BELL SYSTEM PRACTICES
Station Installation and Maintenance

ADDENDUM C46.401
Issue 1, 1-10-34
Standard

SIDETONE AND ANTI-SIDETONE EXTENSION STATION AND EXTENSION RINGER CONNECTIONS

Fig. 1—Low Impedance Ringers—Sidetone Station

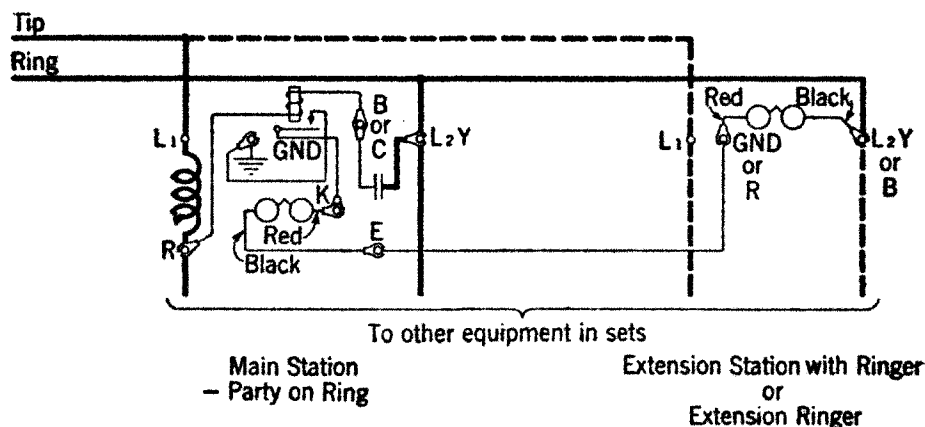
2.07 Four-Party Selective Stations—Manual and Dial — PARTY ON RING

Fig. 3—Low Impedance Ringers—Sidetone Station

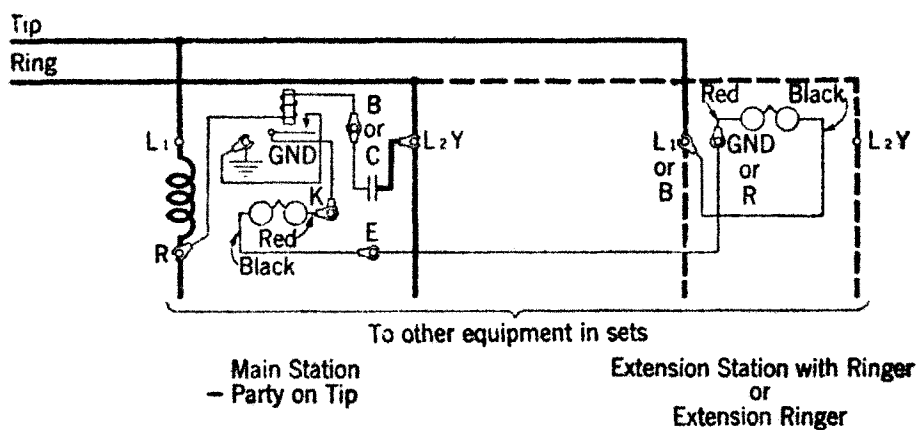
— PARTY ON TIP

Fig. 5—Low Impedance Ringers—Sidetone Station

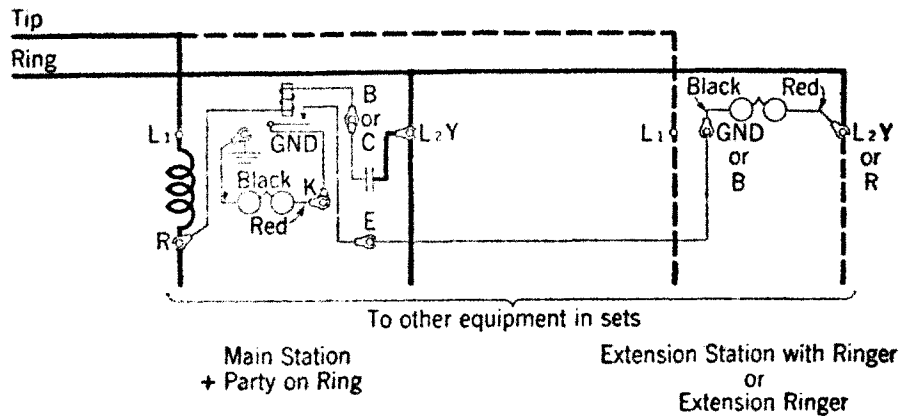
+ PARTY ON RING

Fig. 7—Low Impedance Ringers—Sidetone Station

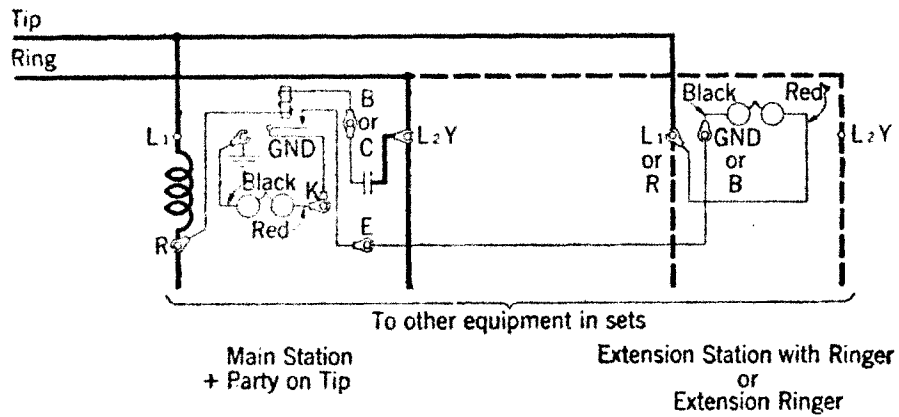
+ PARTY ON TIP
